SAN RAFAEL CITY SCHOOLS
310 Nova Albion Way, San Rafael 94903

ADDENDUM NO. 1
TO
Short Elementary School Early Childhood Education (ECE) Development
BID # 24-08
Addendum Date: 3/14/24

Bid Addendum No. 01

Project: Short ES ECE Development Center
Client: San Rafael City Schools
Project No.: 2023-014.00
DSA A#: 01-121552

Item 1.9– Refer to A1.6 – Exterior Elevations (SEE DRAWINGS SHEETS ATTACHED AFTER THIS PAGE.)

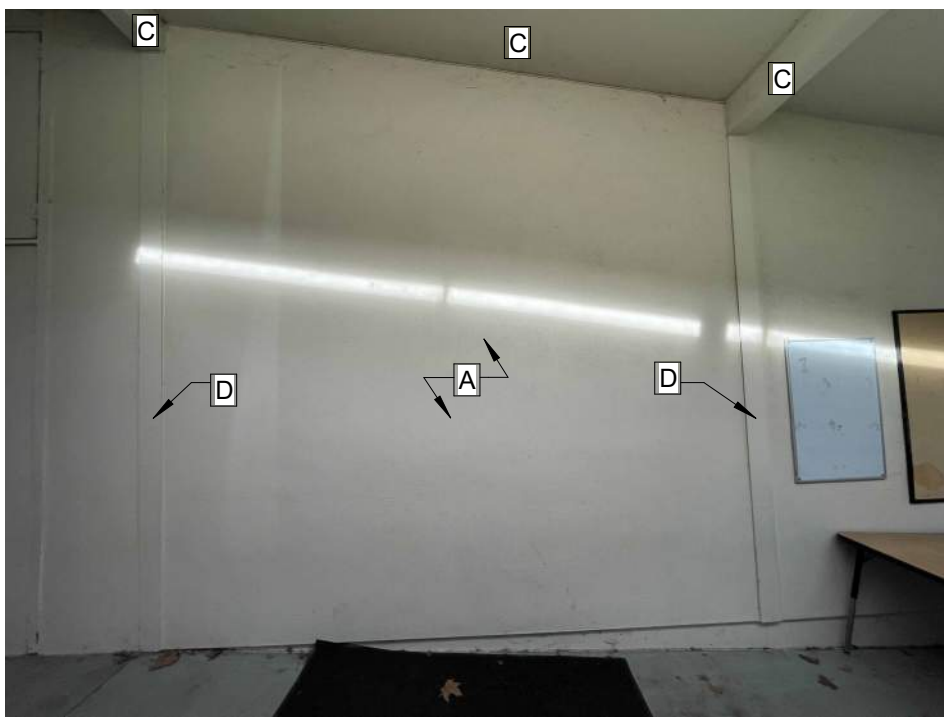
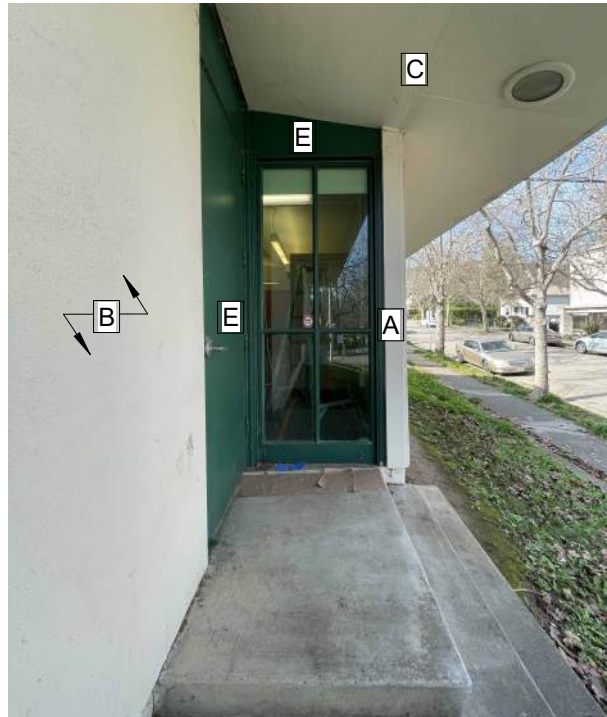
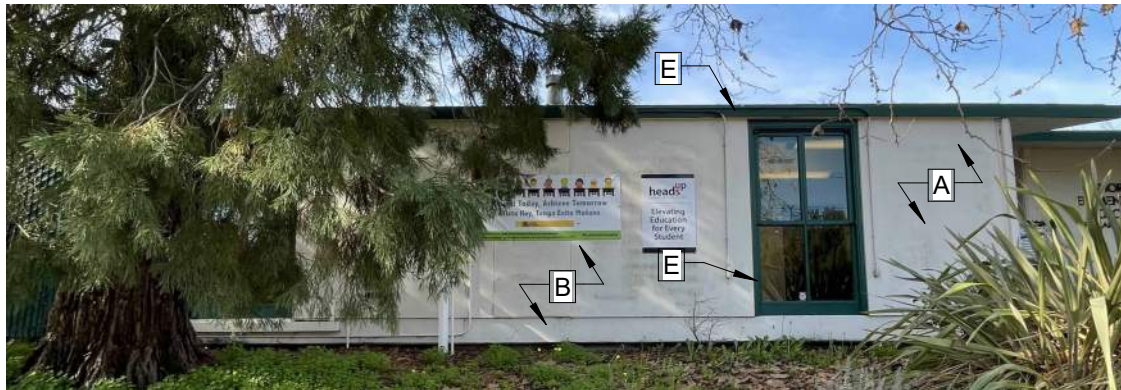
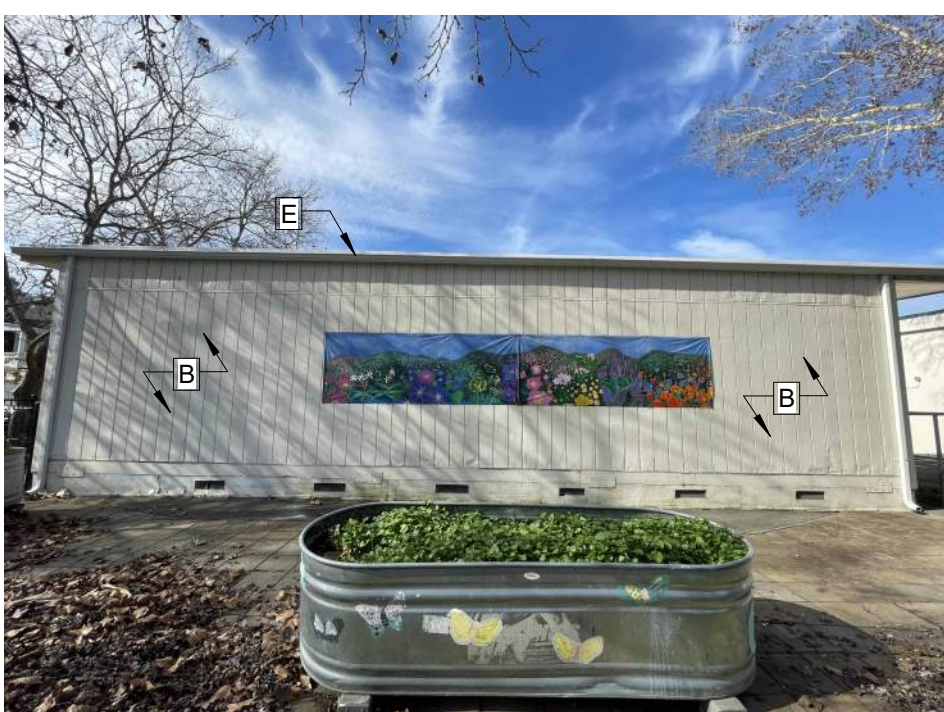
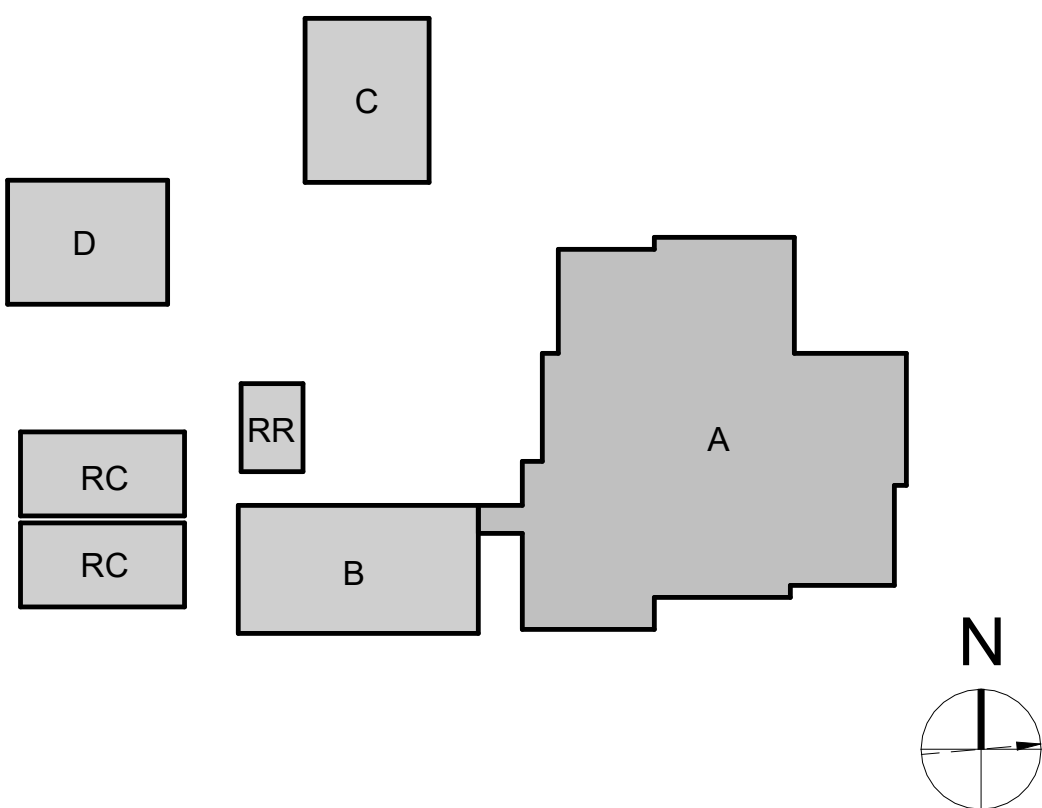
1. Sheet has been updated to indicate colors to be applied throughout the entire campus. PC plans for reference only.

Item 2.0– Refer to A1.7 – Color Option Plan and Typical Elevation (SEE DRAWINGS SHEETS ATTACHED AFTER THIS PAGE.)

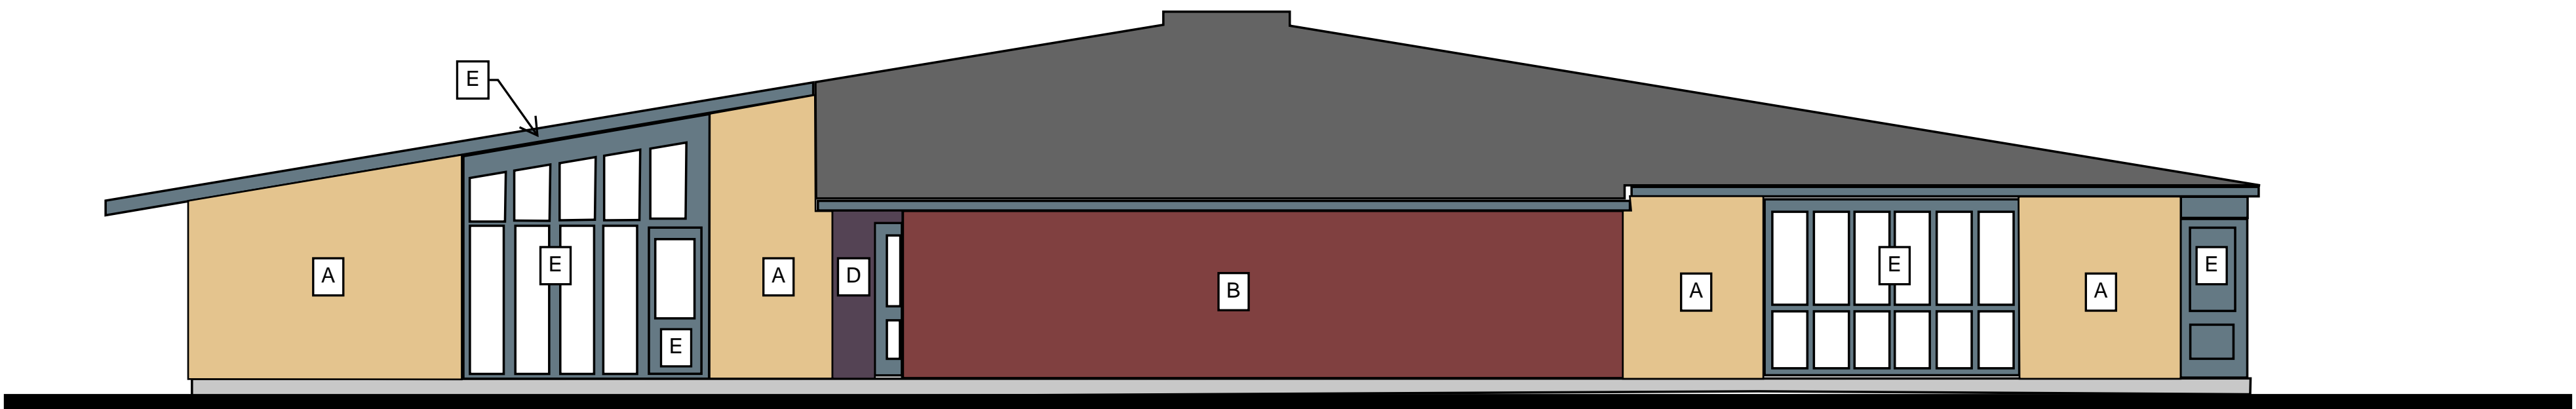
1. Previous elevations with color options have been removed. New elevation shows the colors determined by owner. Also, a new plan indicating the typical application of colors per wall has been added to this sheet. PC plans for reference only.

Item 2.1 – Refer to L1 – Layout Plan

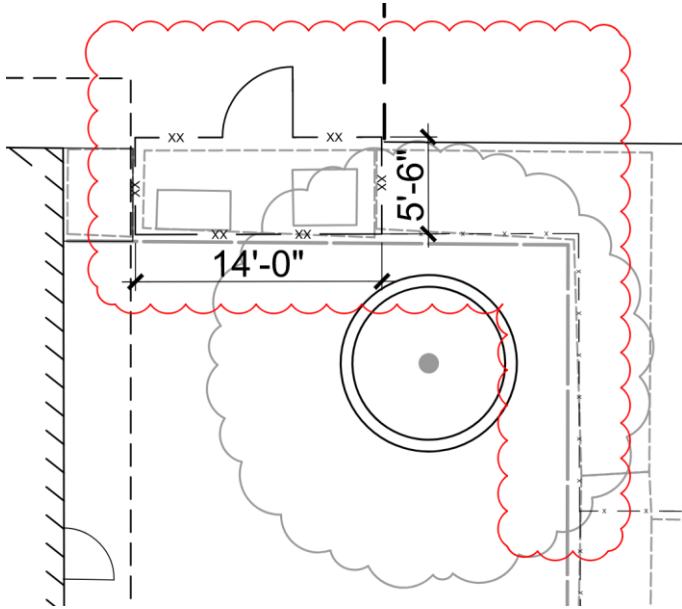
1. Updated layout plan to include all wooden fencing and gate by courtyard and transformer next to Building 'A':

Item 2.2 – Refer to L2 – Material & Detail Reference Plan

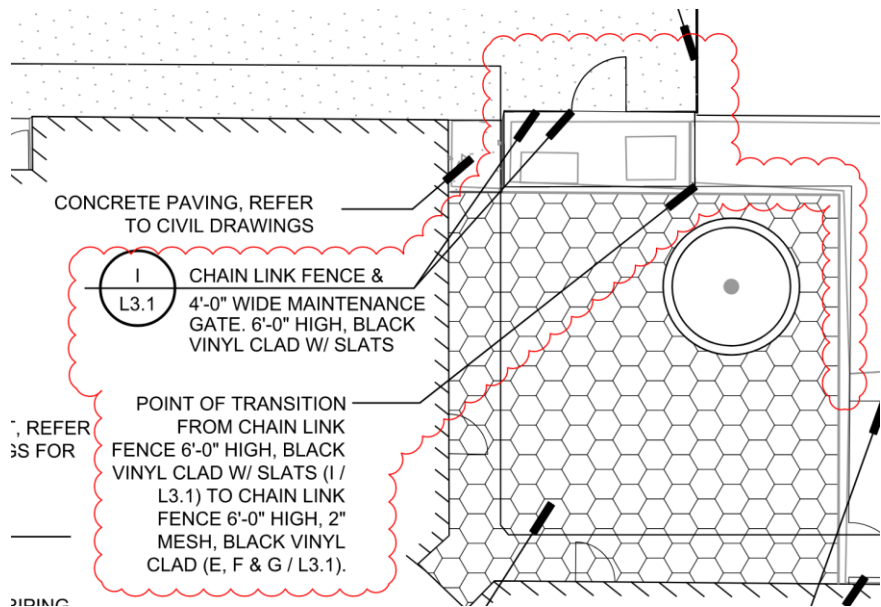
1. New chain-link fencing and maintenance gate added by courtyard and transformer at building 'A.'

2. Updated "Material & Detail Reference Legend" to include new fencing at transformer and courtyard next to building 'A':

3. Clarified that resilient safety surfacing will be owner furnishing will be OFOI.

Item 2.3 – Refer to L3.1 – Construction Details

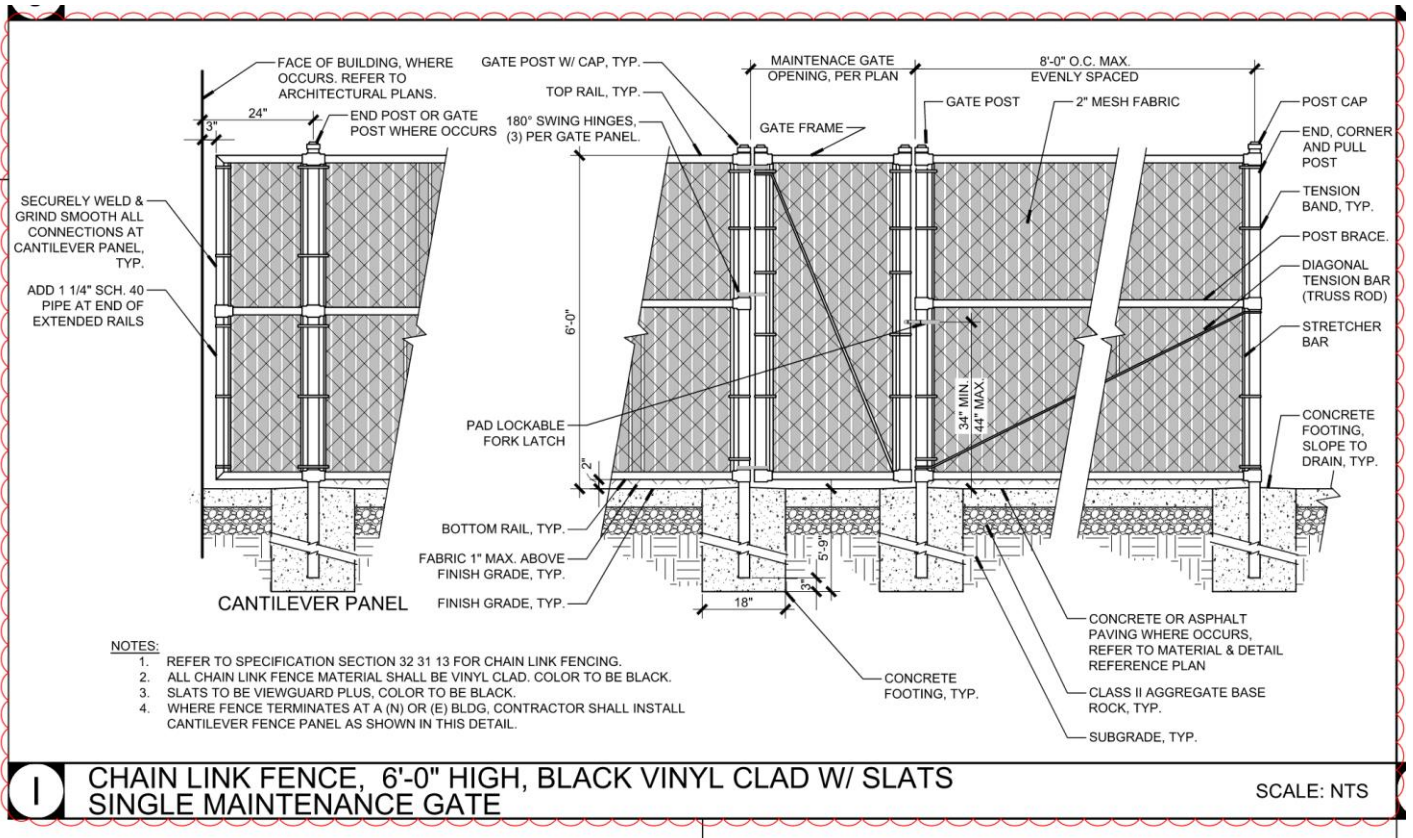
- [Regarding the chain link fence.] The plan details (L3.1) call for 2" mesh with no mention of privacy slats while the specifications (32 13 13-2.2-B) calls for *"2" or 1" diamond mesh (or sized as required for privacy slat inserts)"*.
 - Can you please confirm whether or not these new fences are to receive privacy slats? If these new fences are to receive privacy slats, would you allow for the installation of **pre**-slatted mesh (which is typically available in 3-1/2" diamond opening). This would be the most economical option while achieving the same function and aesthetic as the far less typical smaller diamond slatted material.

- Added detail "I" for new fencing and maintenance gate at transformer and courtyard next to building 'A':

Response 4: Pre-slatted is acceptable for the fencing and gate surrounding the existing electrical enclosure only.
